Questions about Asynchronous Traffic Shaping

Norman Finn
Cisco Systems

March 22, 2016

The setup:

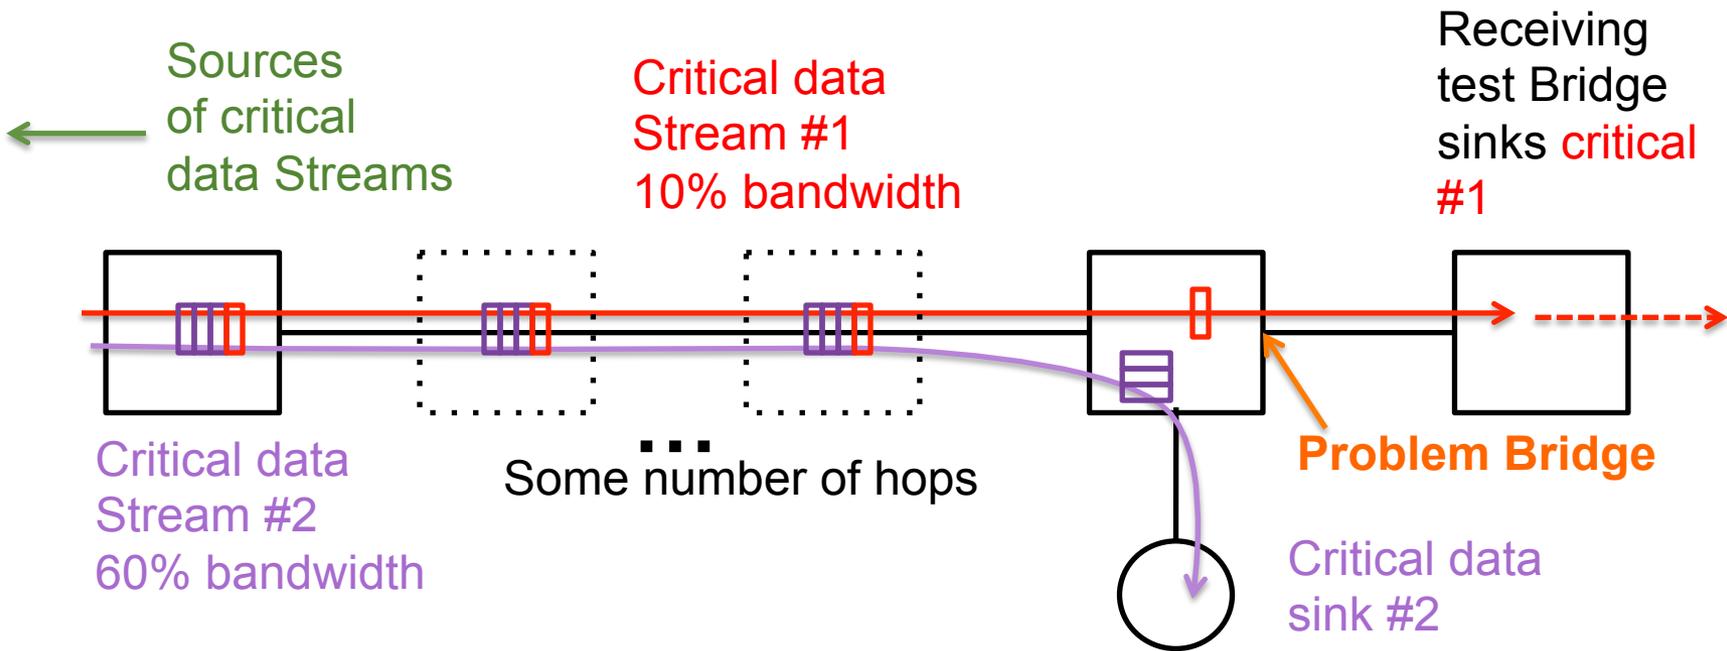
- Two critical Streams:
 - **Stream #1:** 10% of line rate.
 - **Stream #2:** 60% of line rate.
- Both Streams take the same route until the “Problem Bridge”.
- Both Streams use the same Asynchronous shapers until the Problem Bridge, because both take the same path.

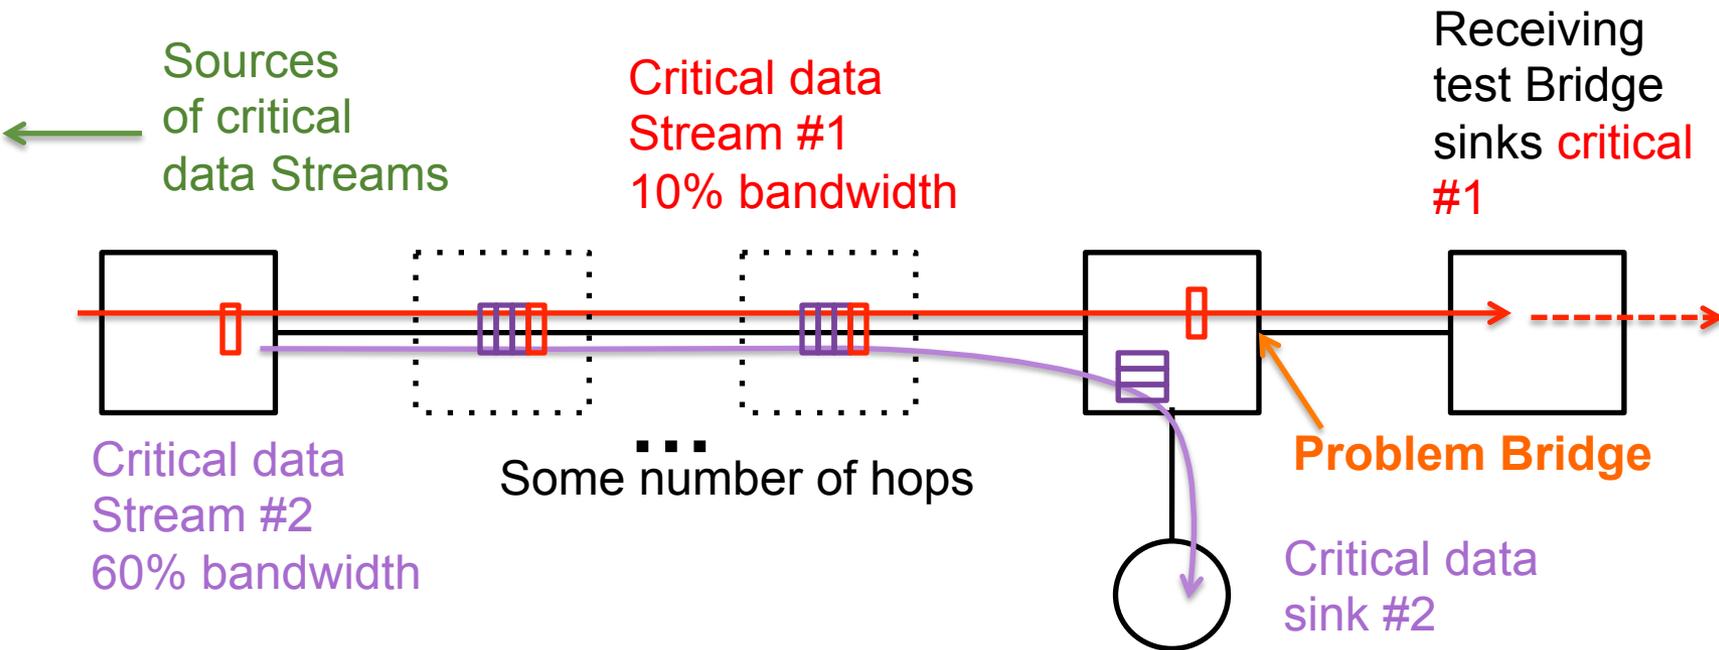
- Queues become occupied to the expected, normal, non-0 level.
- Each asynchronous queue is partly filled with packets from **Stream #1**, partly filled with packets from **Stream #2**.
- **NOTE:** We are only looking at the **asynchronous shaper queues**, not the simple queues into which they dump.

The sting:

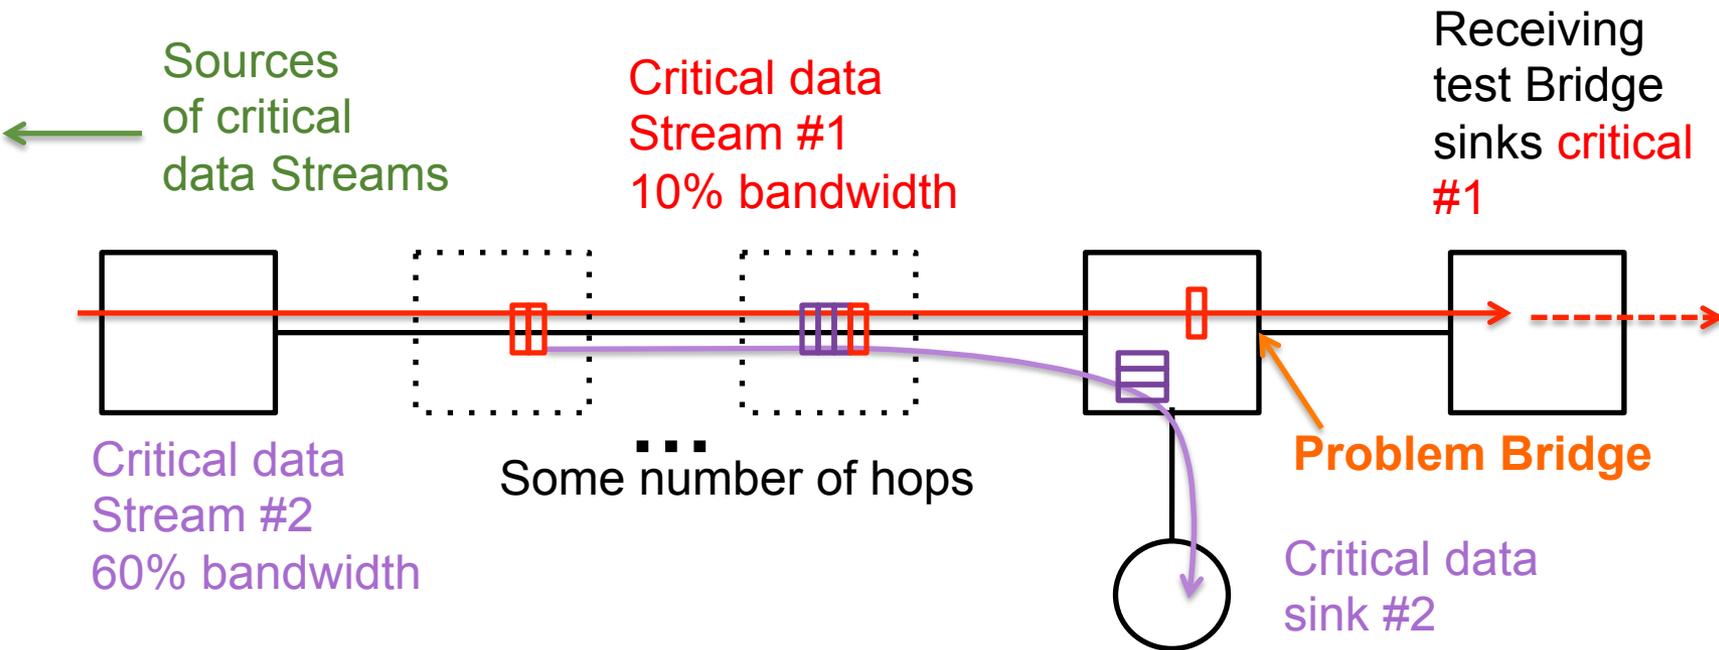
- The source of critical Stream #2 stops transmitting.
- Critical Stream #1 starts draining at 70% line rate towards the right.

The sting:

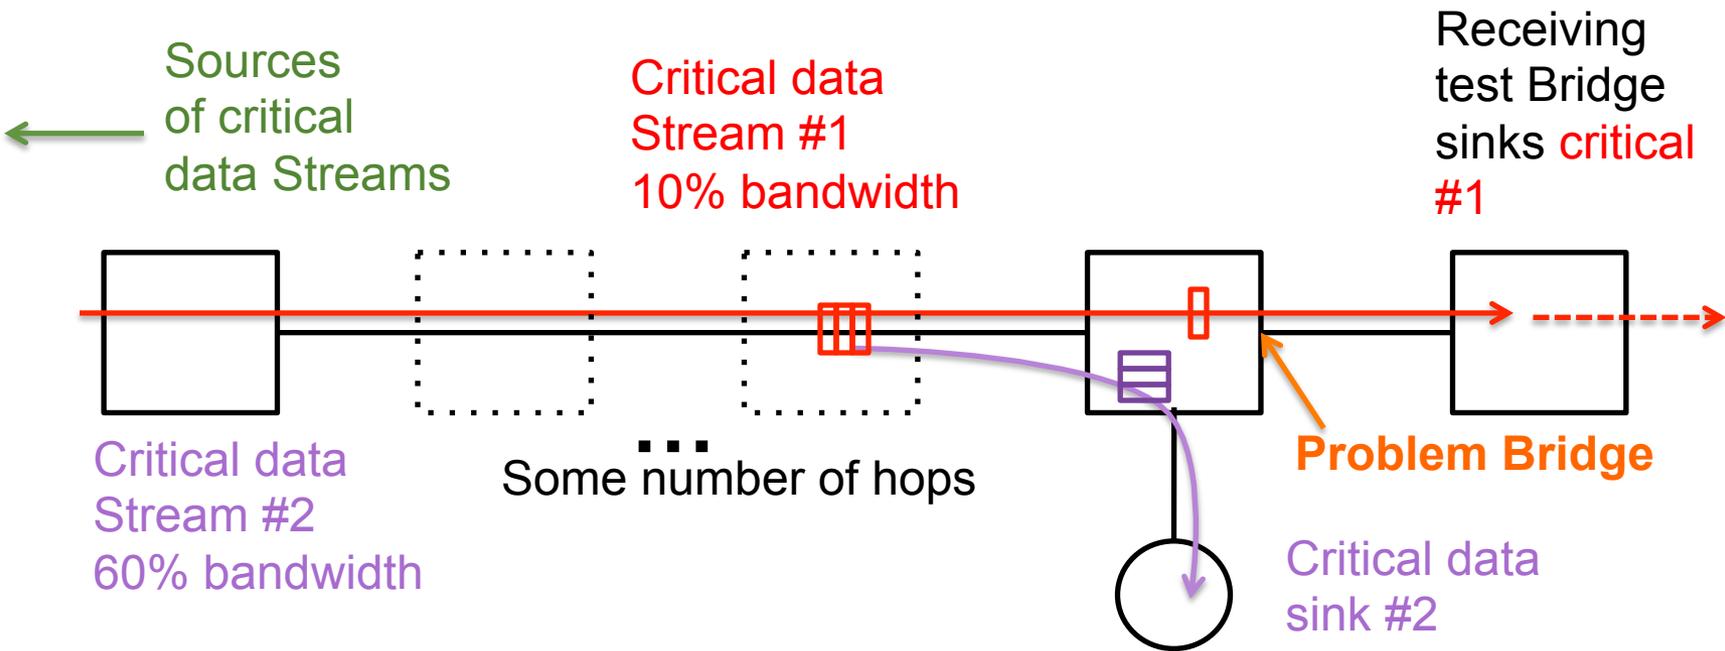
- The source of critical Stream #2 stops transmitting.
- Critical Stream #1 starts draining at 70% line rate towards the right.

The sting:

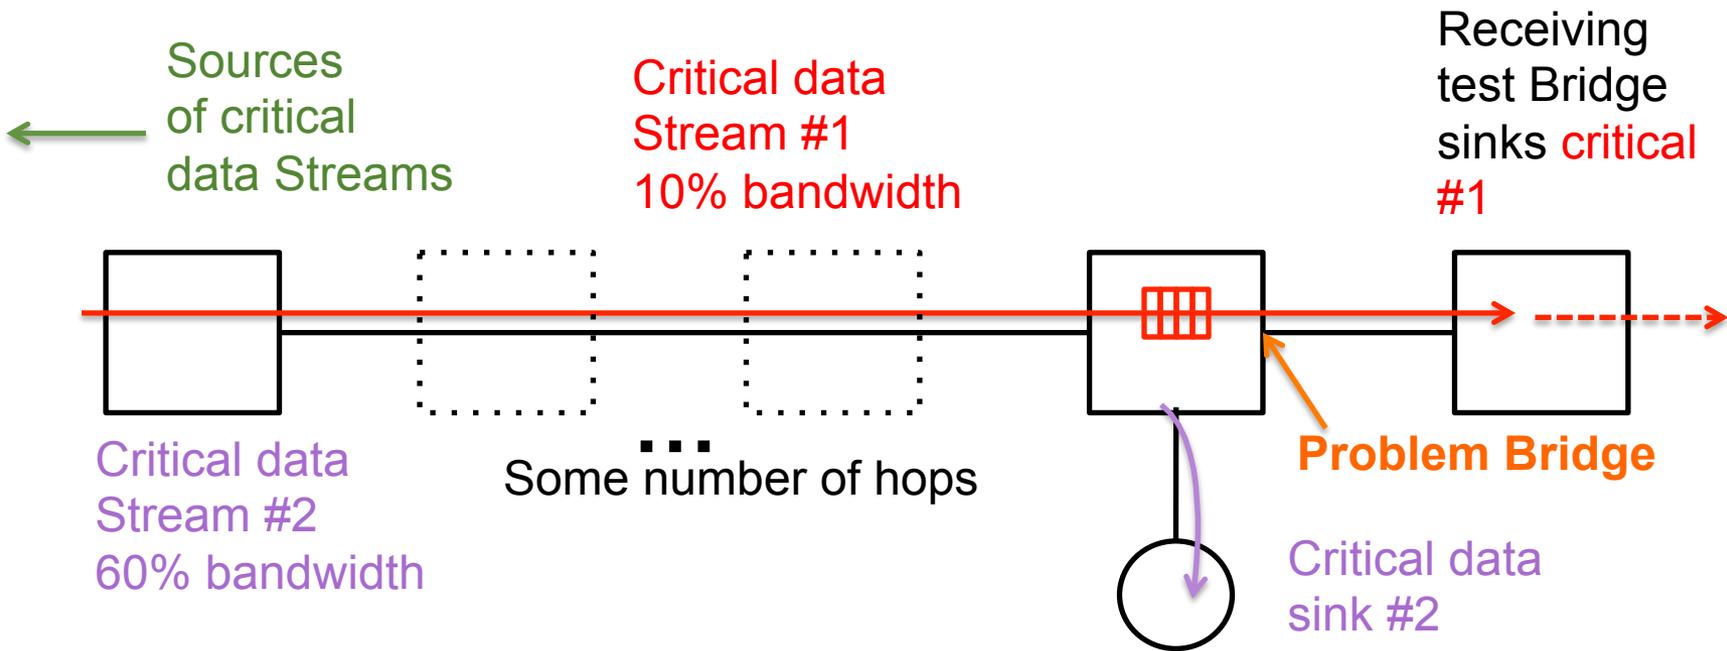
- The source of critical Stream #2 stops transmitting.
- Critical Stream #1 starts draining at 70% line rate towards the right.

- The source of critical Stream #2 stops transmitting.
- Critical Stream #1 starts draining at 70% line rate towards the right.
- **The asynchronous buffer in Problem Bridge is still draining at 10% line rate. It must store a number of packets proportional to the number of hops.**

1. Does this mean you can “pump” the rightmost queue until it fills, no matter how big it is?
 - Answer: **“No. It’s OK.”** If you turn Stream #2 back on, it will cause delays in Stream #1 that will allow the rightmost queue to empty before cutting off Stream #2 fills it, again.
2. Aren’t we back where we were when Christian Boiger pointed out the AVB problems?
 - It would seem so.
3. Don’t we need per-Stream asynchronous queues, instead of per-input-port asynchronous queues?
 - It would seem so. Per-Stream queues would prevent the bunch-up.
